STAFF REPORT

SUBJECT: H-2022-0034
 Lot 8 Retail Building – CUP

LOCATION: 3333 W. Chinden Blvd. in the NE 1/4 of Section 27, T.4N., R.1W. (Lot 8, Block 1, Lost Rapids Subdivision)

C. Building Elevations (dated: 4/27/22)

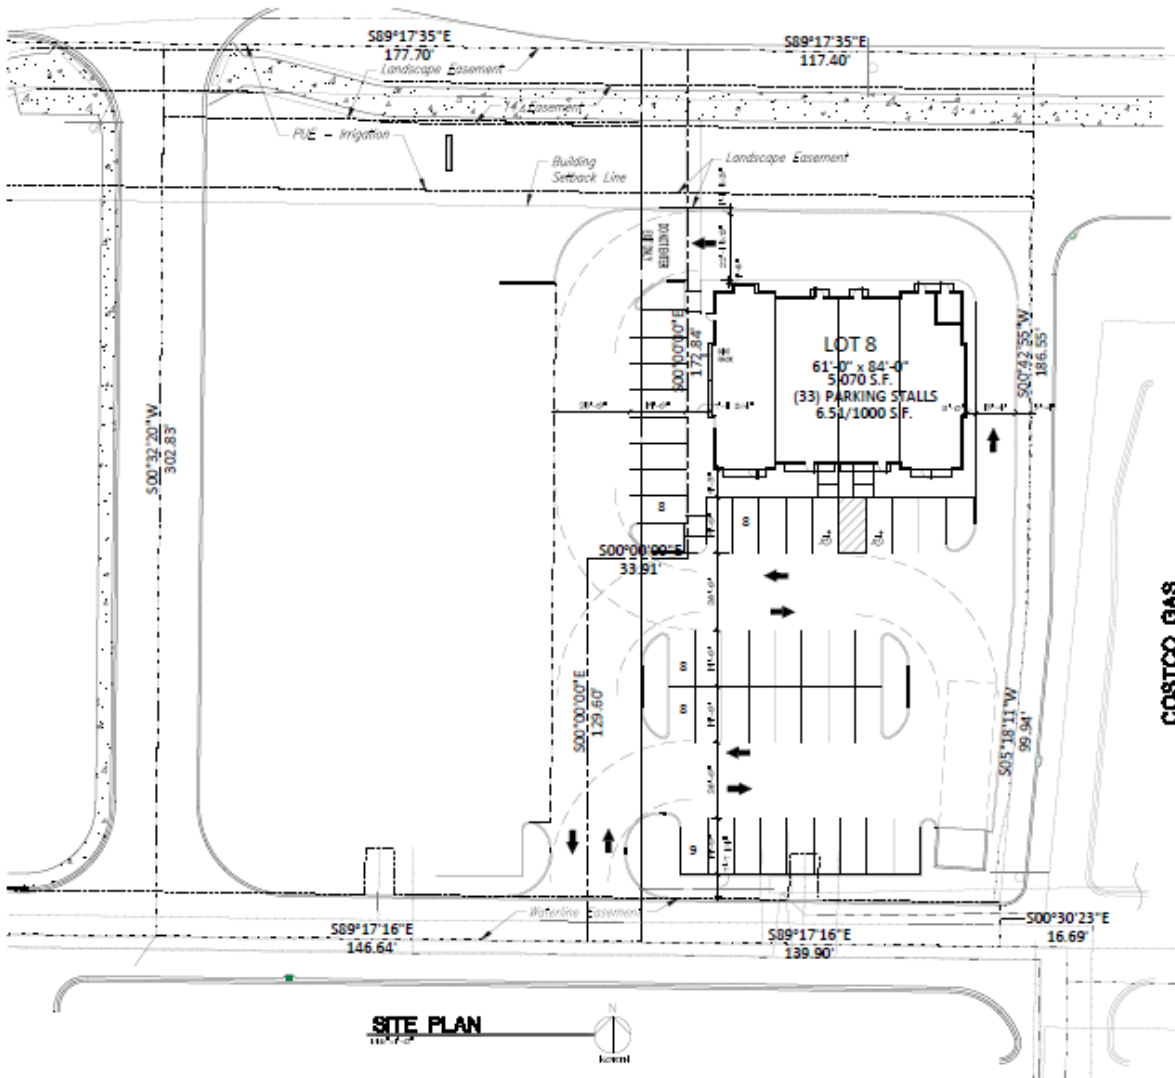
Mechanical Equipment: All mechanical equipment on the back of the building and outdoor service and equipment should be incorporated into the overall design of buildings and landscaping so that the visual and acoustic impacts of these functions are fully contained and out of view from adjacent properties and public streets as set forth in UDC [11-3A-12](#).

Building Elevations: Conceptual building elevations were submitted as shown in Section VII.C for a single-story building that incorporates a mix of materials consisting of stucco, horizontal siding, manufactured stone, windows and metal roofing. **The final design shall be consistent with the design standards listed in the [Architectural Standards Manual](#).**

- b. All mechanical equipment on the back of the building and outdoor service and equipment areas should be incorporated into the overall design of buildings and landscaping so that the visual and acoustic impacts of these functions are fully contained and out of view from adjacent properties and public streets as set forth in UDC [11-3A-12](#).

6. A Certificate of Zoning Compliance and Design Review application shall be submitted and approved for the proposed use prior to submittal of a building permit application. The design of the site and structure shall comply with the standards listed in UDC [11-3A-19](#); the design standards listed in the *Architectural Standards Manual* and with the Development Agreement.

A. Proposed Site Plan (dated: 4/27/2022)

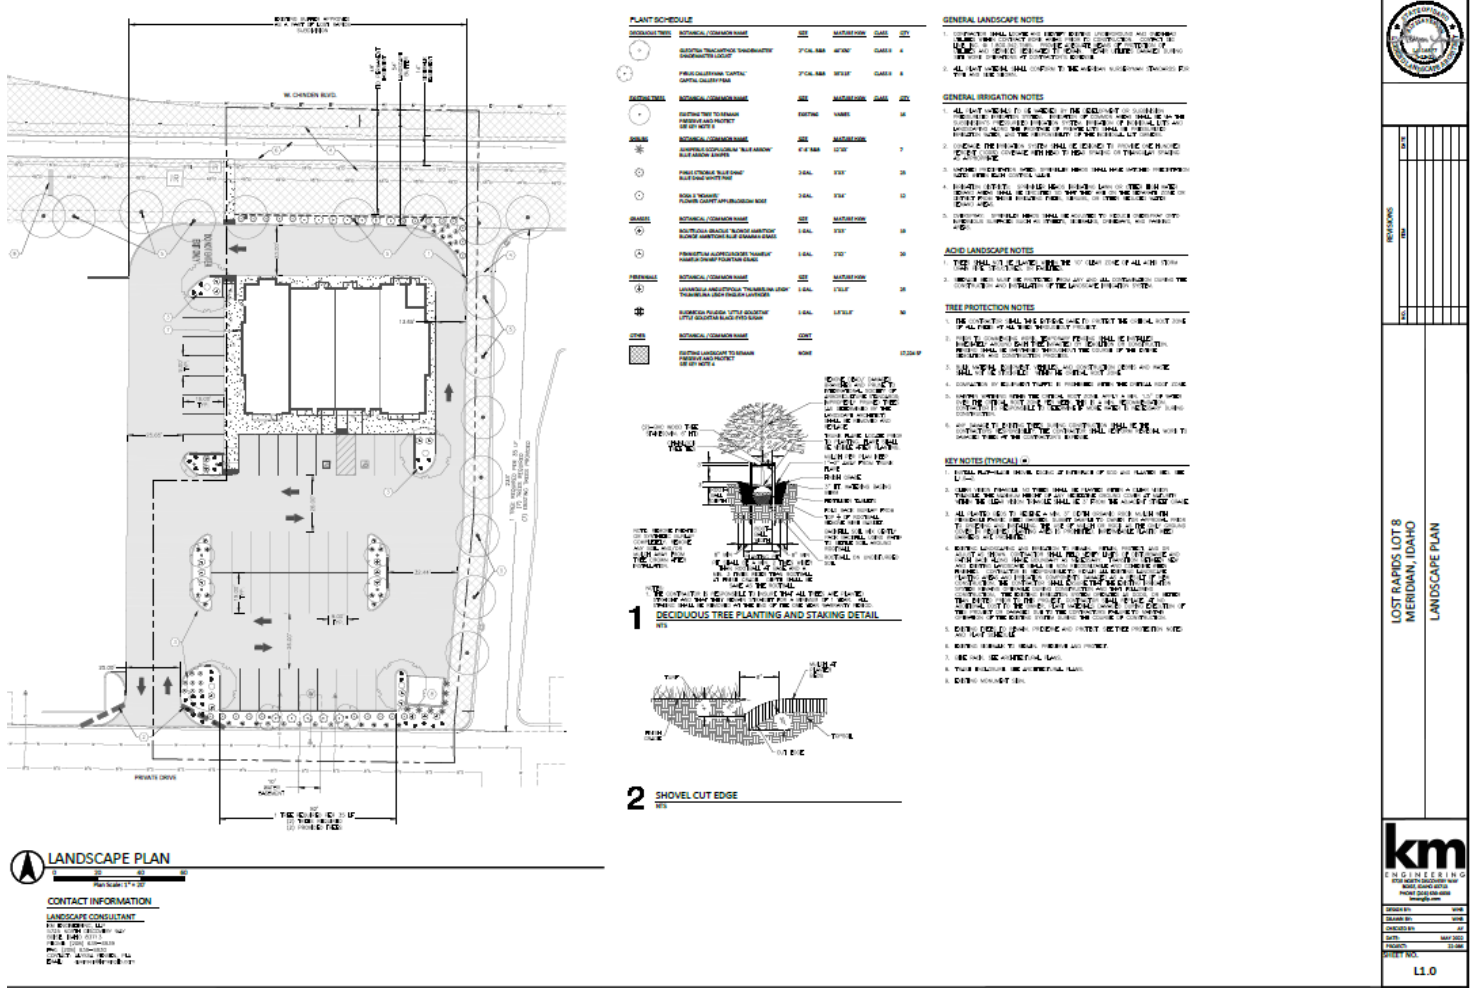
The configuration of the property depicted on the plans does not match that of Lot 8 shown on the recorded plat for Lost Rapids subdivision. **A property boundary adjustment application should be approved prior to issuance of a building permit for this property.**

The drive-through will provide queuing for 9+/- vehicles, which should be adequate to prevent obstruction of internal drive aisles.

The stacking lane is a separate lane from the circulation lanes needed for access and parking.

The stacking lane is not located within 10' of any residential district or residence.

The stacking lane exceeds 100' in length and an escape lane is proposed.

The drive-through is located on the north side of the building and is visible from W. Chinden Blvd. for surveillance purposes.

Access: A north/south access driveway exists via W. Chinden Blvd. for this development that runs along the west boundary of the abutting lot to the west. Another east/west driveway runs along the south boundary of this site from which access is proposed; this access is shared with the abutting lot to the west. Direct lot access via Chinden Blvd. is prohibited. A reciprocal cross-access easement exists between all lots in the subdivision as noted on the Lost Rapids subdivision plat.

Parking: As noted above, UDC 11-4-3-49 includes specific parking standards for restaurants, which the site plan demonstrates compliance with. A minimum of 20 off-street vehicle parking spaces are required for the 5,070 square foot building per the restaurant standards; 35 are proposed, in excess of the minimum standards.

A minimum of one (1) bicycle parking space is required to be provided for every 25 vehicle spaces or portion thereof per UDC [11-3C-6G](#); bicycle parking facilities are required to comply with the location and design standards listed in UDC [11-3C-5C](#). A bicycle rack is proposed on the east side of the building which should accommodate a minimum of two (2) bicycles.

Sidewalks: A 10-foot wide sidewalk/multi-use pathway exists within the street buffer along W. Chinden Blvd. **A pedestrian walkway is required to be provided from the perimeter sidewalk along W. Chinden Blvd. to the main building entrance per UDC 11-3A-19B.4. Where the walkway crosses the vehicular driving surface, it's required to be distinguished through the use of pavers, colored or scored concrete, or bricks as set forth in UDC 11-3A-19B.4. The site/landscape plan submitted with the Certificate of Zoning Compliance application should be revised to reflect compliance with this standard.**

2. The site plan and landscape plan submitted with the Certificate of Zoning Compliance application shall be revised as follows:
 - a. The stacking lane, menu and speaker location(s), and window location shall be depicted in accord with UDC [11-4-3-11B](#).

- c. Depict a minimum 5-foot wide pedestrian walkway from the perimeter sidewalk along W. Chinden Blvd. to the main building entrance per UDC [11-3A-19B.4](#). The pathway shall be distinguished from the vehicular driving surface through the use of pavers, colored or scored concrete, or bricks as set forth in UDC 11-3A-19B.4b.

- d. Depict all easements that exist on the subject lot per the recorded plat (Lost Rapids Subdivision). Any encroachments within existing easements should be permitted through the easement holder and/or as allowed by the UDC.

- f. Widen the perimeter buffer along the south boundary of the site to 7 feet to allow 2 feet of vehicle overhang (parking stalls may be decreased to 17 feet in length); or, provide wheel stops in parking spaces to prevent vehicle overhang, as set forth in UDC 11-3C-5B.4.

- g. Depict safe pedestrian access to the adjacent property to the west as set forth in UDC [11-4-3-11C](#). Work with the property owner to the west on a common location for the walkway. *Pedestrian access is not required to the property to the east as it's a fuel facility.*

5. A property boundary adjustment application shall be approved for the proposed configuration of the property prior to issuance of a building permit for this site.

B. Proposed Landscape Plan (dated: 5/13/22)

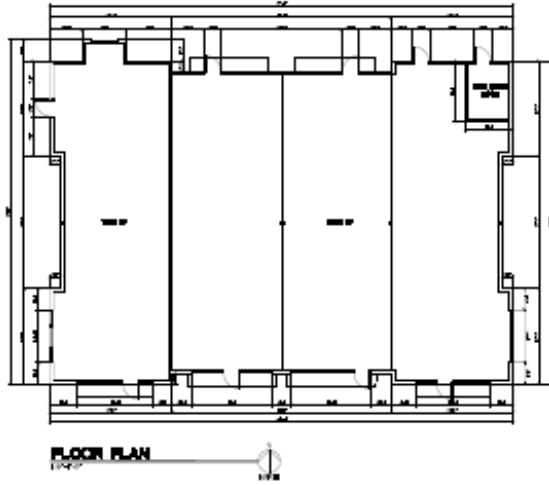
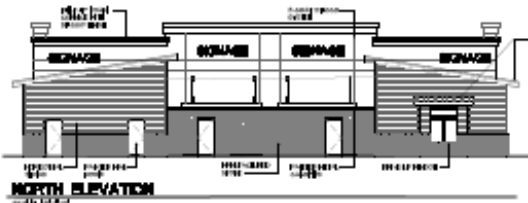
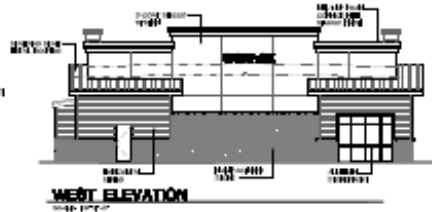
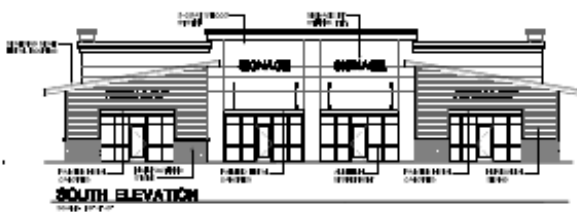
Landscaping: Street buffer landscaping was installed within the street buffer along W. Chinden Blvd. with the Lost Rapids subdivision improvements.

Parking lot landscaping is required to be provided in accord with the standards listed in UDC [11-3B-8C](#). Shrubs should be included in the perimeter buffer along the east boundary of the site in accord with UDC 11-3B-7C.1b. The buffer along the south boundary of the site should be widened to a minimum of 7 feet to allow for 2 feet of vehicle overhang in accord with UDC 11-3C-5B.4 – parking stalls may be reduced to 17 feet in length; or, wheel stops may be provided in parking spaces to prevent vehicle overhang. The landscape plan submitted with the Certificate

of Zoning Compliance application should be revised to reflect compliance with these standards.

- e. Depict landscaping in the perimeter buffer along the east boundary of the site in accord with the standards listed in UDC [11-3B-8C](#) (*shrubs should be included*).
